**TO:** Casey Adragna, Adragna Architecture  
**FROM:** Elizabeth Steward, Associate Planner- Development Review  
**DATE:** 10/27/25  
**SUBJECT:** Douglas 234 Multitenant, Site Plan  
Review Comments 02

SITE PLAN  
**HORSE CREEK COMMERCIAL**  
 LOT 10B, DOUGLAS 234 FILING NO. 6, AMENDMENT 2  
 A PORTION OF THE SW 1/4, SE 1/4, SECTION 29, T6S, R66W, 6TH P.M.  
 TOWN OF PARKER, COUNTY OF DOUGLAS, STATE OF COLORADO

COVER SHEET  
 DOUGLAS 234 FILING NO. 6, AMD. 2  
 JOB NO. 24020  
 DATE: OCTOBER 3, 2025  
 SHEET C1

GRADING PLAN  
 DOUGLAS 234 FILING NO. 6, AMD. 2  
 JOB NO. 24020  
 DATE: OCTOBER 3, 2025  
 SHEET C4

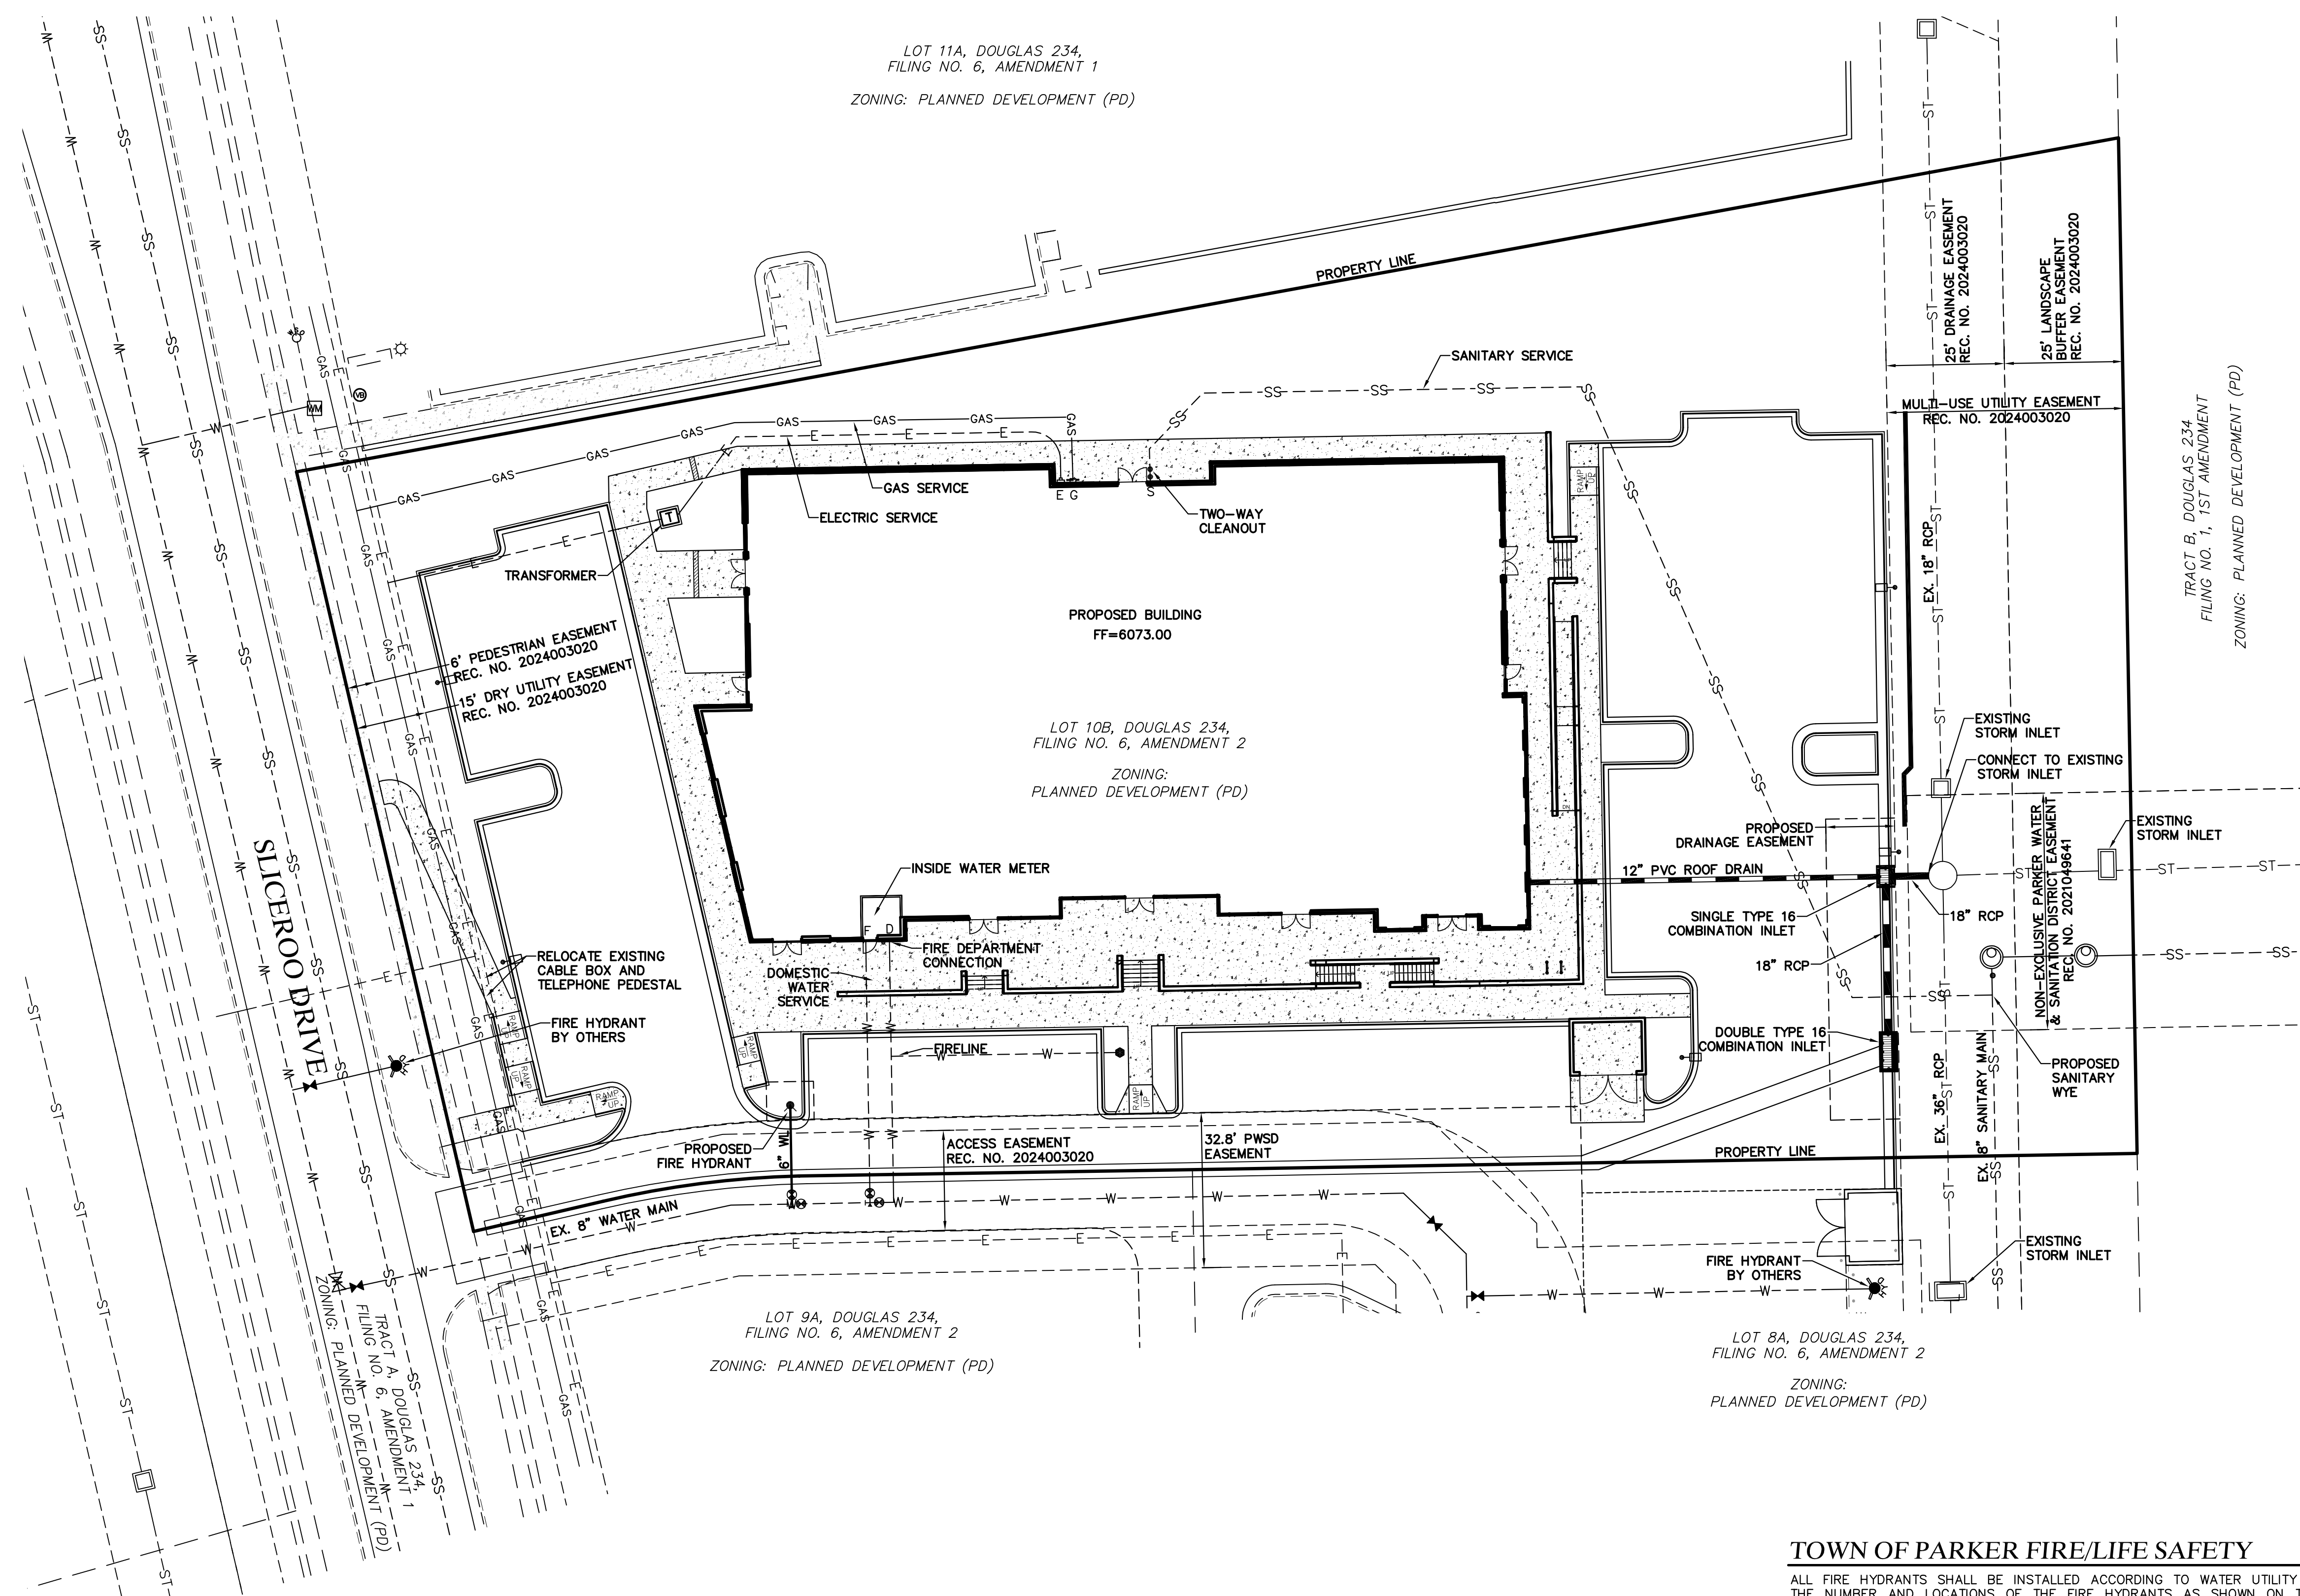
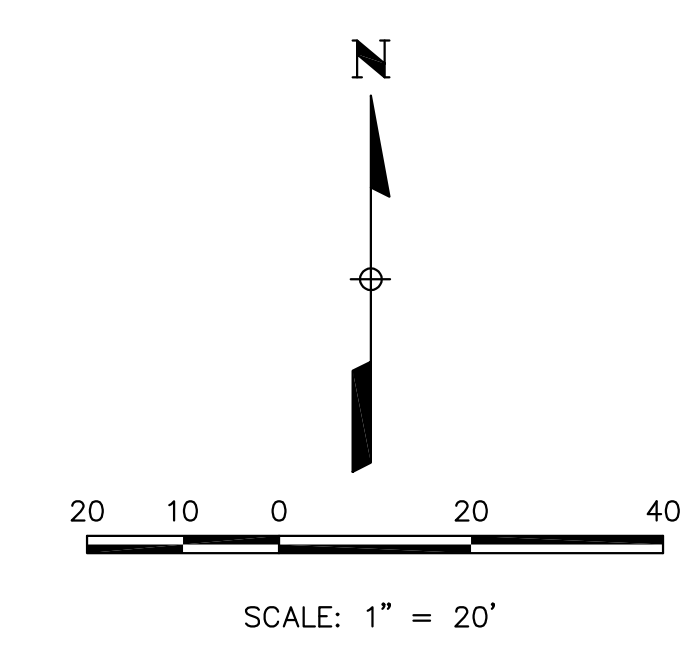
retaining walls a maximum height of 6 feet per section 13.08.090 (n) (4), this will need to be changed.

Remove off site improvements.

Walls have been tiered in this area so they do not exceed 6 feet in height.

OK

SITE PHOTOMETRIC PLAN  
DOUGLAS 234 FILING NO. 6, AMD. 2  
DATE: OCTOBER 2, 2025  
SHEET LT1

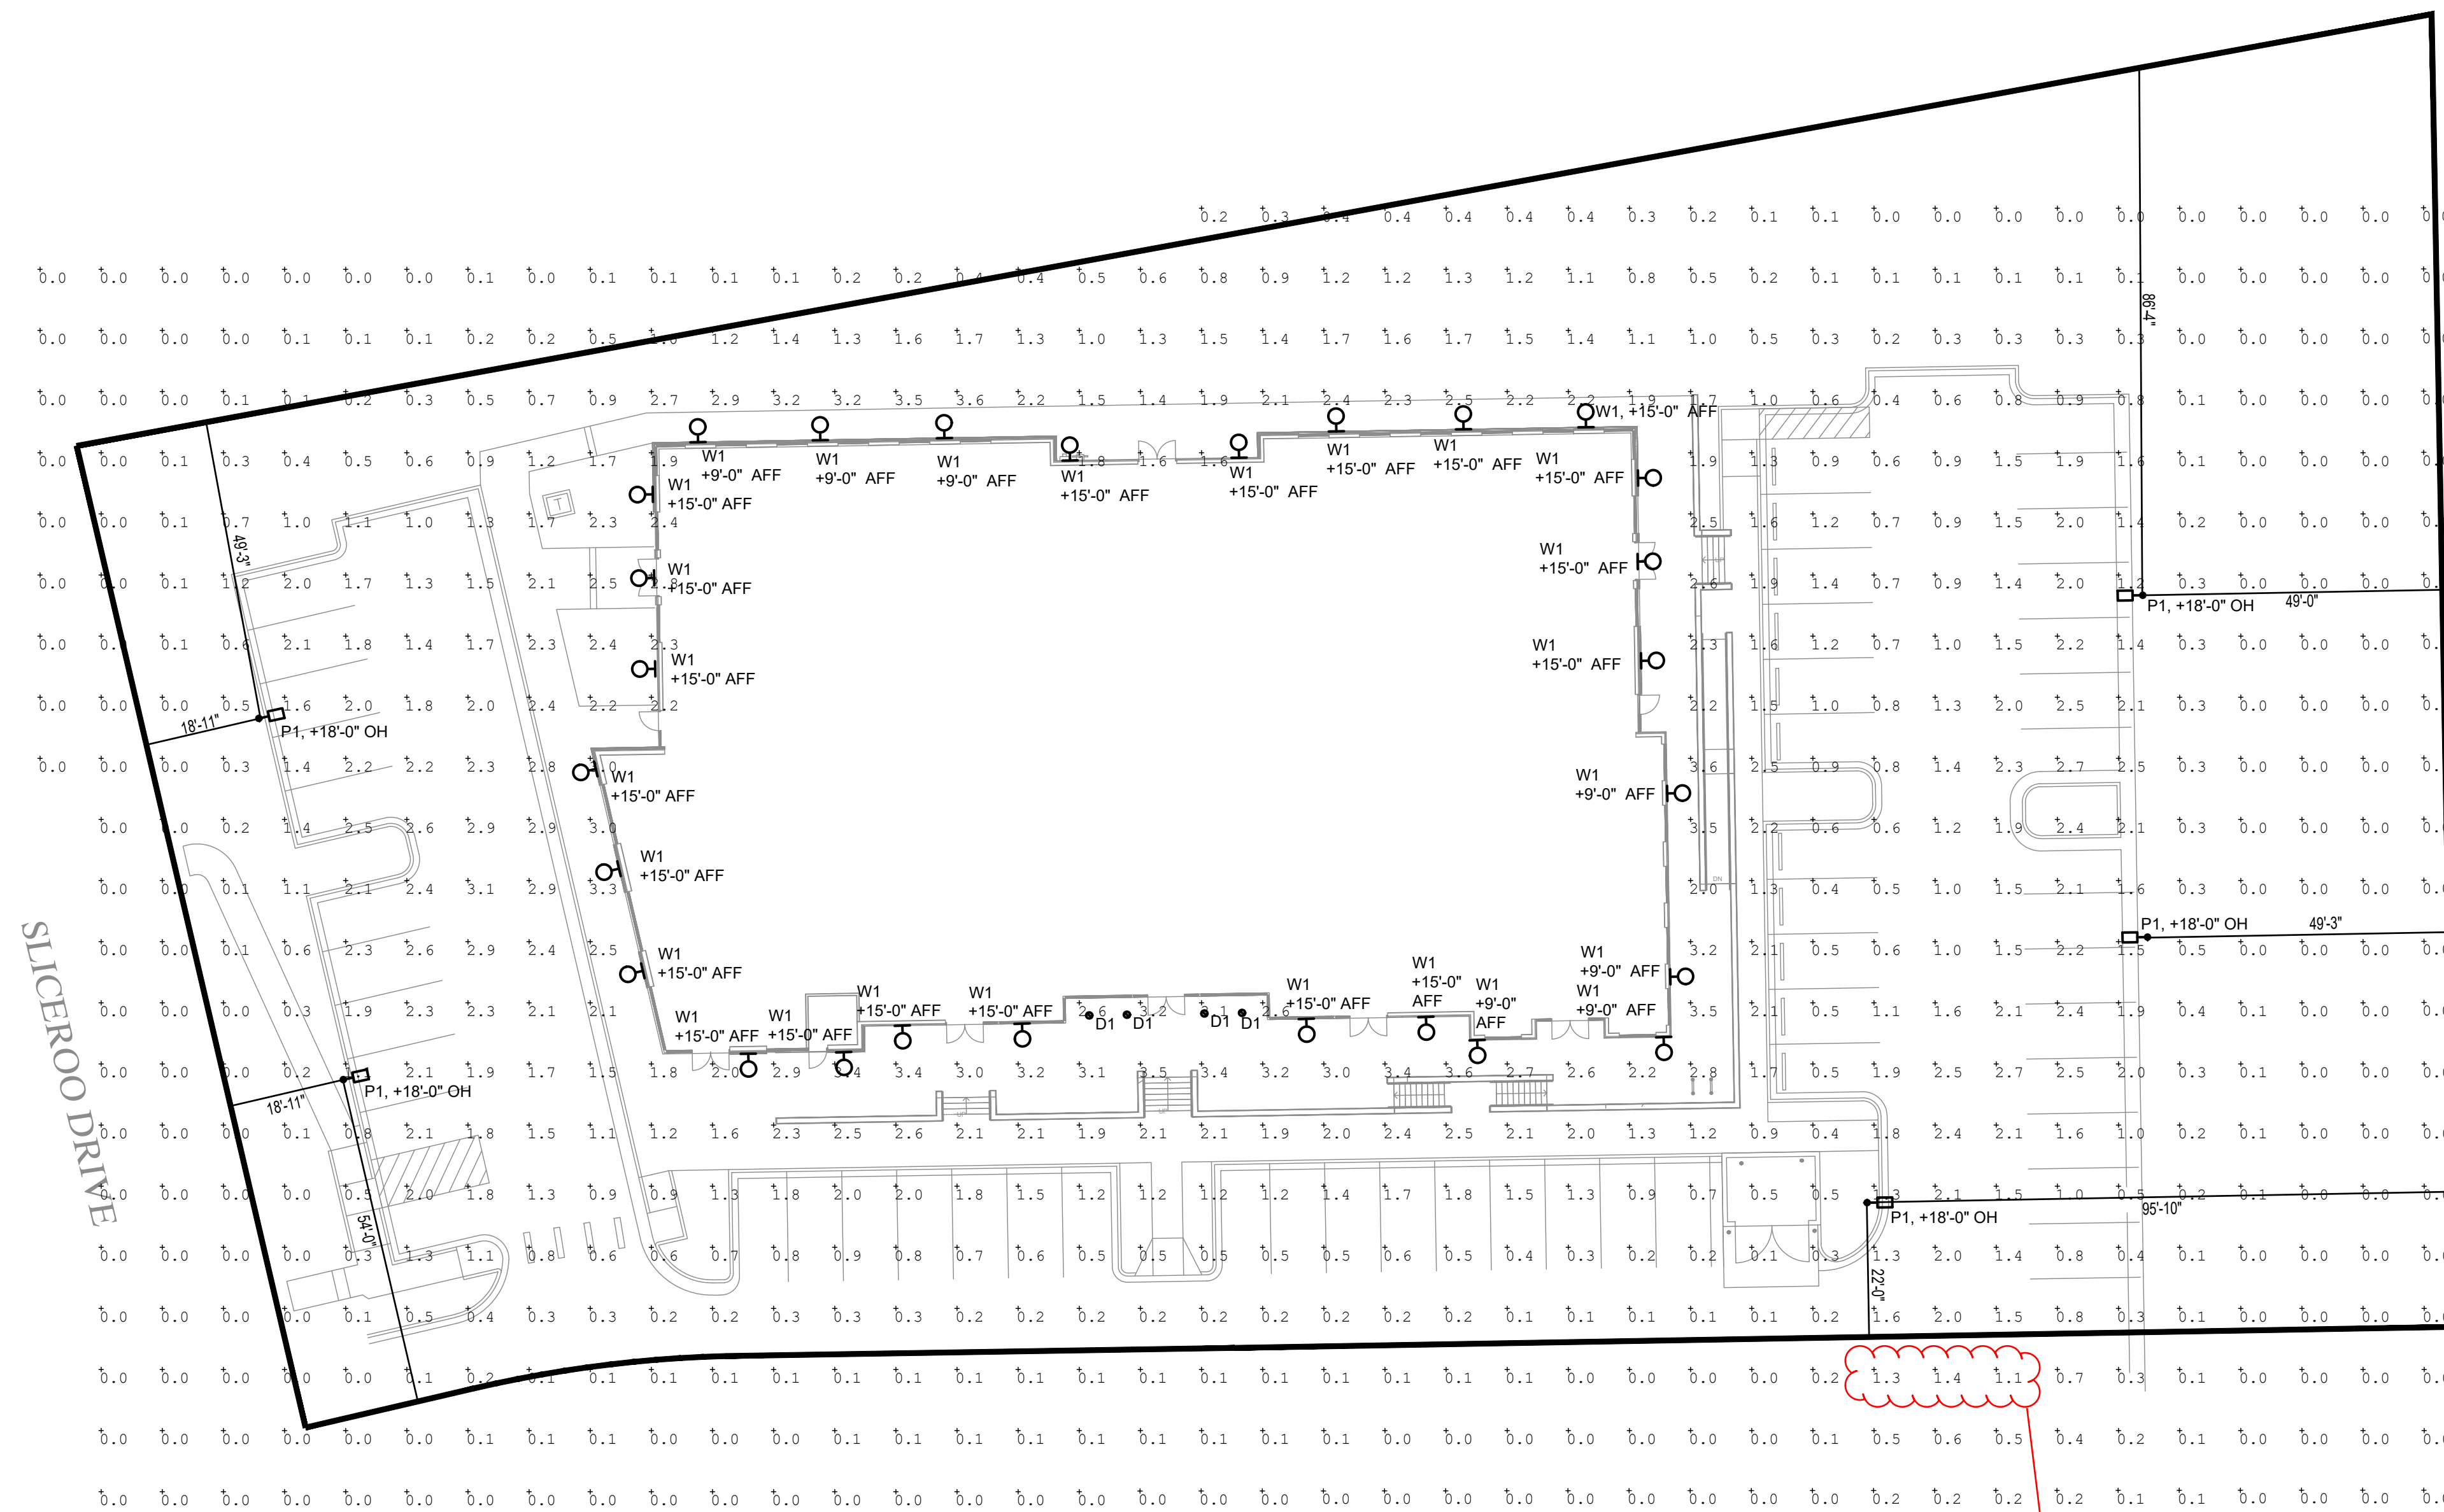
maximum height of mounted lighting is 15ft, please ensure this is below this, add label of height of mounting.

Maximum lumens at property line is 1 per section 13.08.110 (4)

REVISED

REVISED
